Access Compliance Report

(Curb Ramps)

Intersection ID: 31279	Main Street: MALLARD_GLEN_DR	Cross Street: GARRETT_GRIGG_RD	Location: E
ADA ID: C1C127A0344B	Ramp Type: PerpDiag	Initial Pass/Fail: Fail	Overall Compliance: No
Codes/Mitigation Info/Possible Solution		Field Measurements/Component Compliance

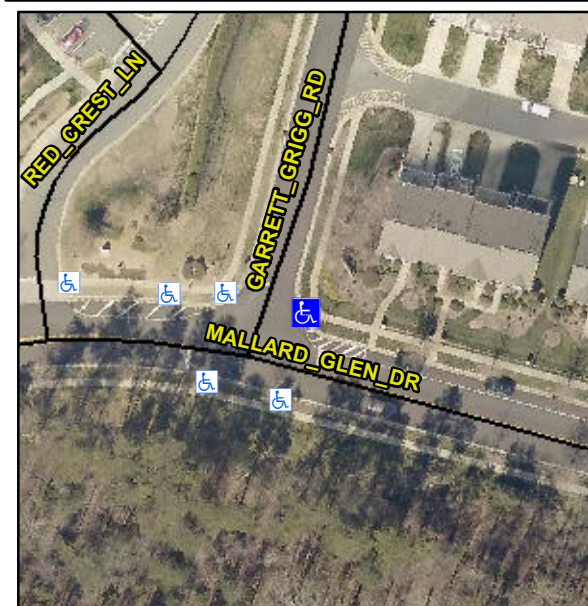
Not Found, R304.5.1, R304.5.3

Compliance	Description	Data	Compliance	Description	Data
N/A	Ramp Length (in)	62.0	Yes	Ramp Slope (%)	5.0
No	Ramp Width (in)	40.0	No	Ramp XSlope (%)	5.6
N/A	Flare Type LT	N/A	N/A	Flare Type RT	N/A
N/A	Flare Slope LT (%)	N/A	N/A	Flare Slope RT (%)	N/A
N/A	Flare Traversable LT?	N/A	N/A	Flare Traversable RT?	N/A
N/A	Landing Length (in)	N/A	N/A	DWS Provided?	N/A
N/A	Landing Width (in)	N/A	N/A	DWS Contrast?	N/A
N/A	Landing Slope (%)	N/A	N/A	DWS Length (in)	N/A
N/A	Landing X Slope (%)	N/A	N/A	DWS Full Width?	N/A
N/A	Landing Curb? (Y/N)	N/A	N/A	DWS Offset (in)	N/A
N/A	Shared Landing?	N/A			
N/A	Gutter Ponding?	N/A	N/A	Gutter Slope (%)	N/A
N/A	Gutter Lip Ht (in)	N/A	N/A	Gutter X Slope (%)	N/A
N/A	Painted X Walk1?	No	N/A	Painted X Walk2?	No
	X Walk 1 Direction	To NW		X Walk 2 Direction	To SW
N/A	X Walk 1 Width (in)	N/A	N/A	X Walk 2 Width (in)	N/A
	X Walk 1 Slope (%)	7.2		X Walk 2 Slope (%)	1.7
	X Walk 1 X Slope (%)	3.8		X Walk 2 X Slope (%)	5.9

Remove & Replace Curb Ramp With Two New Directional Ramps or Equivalent.
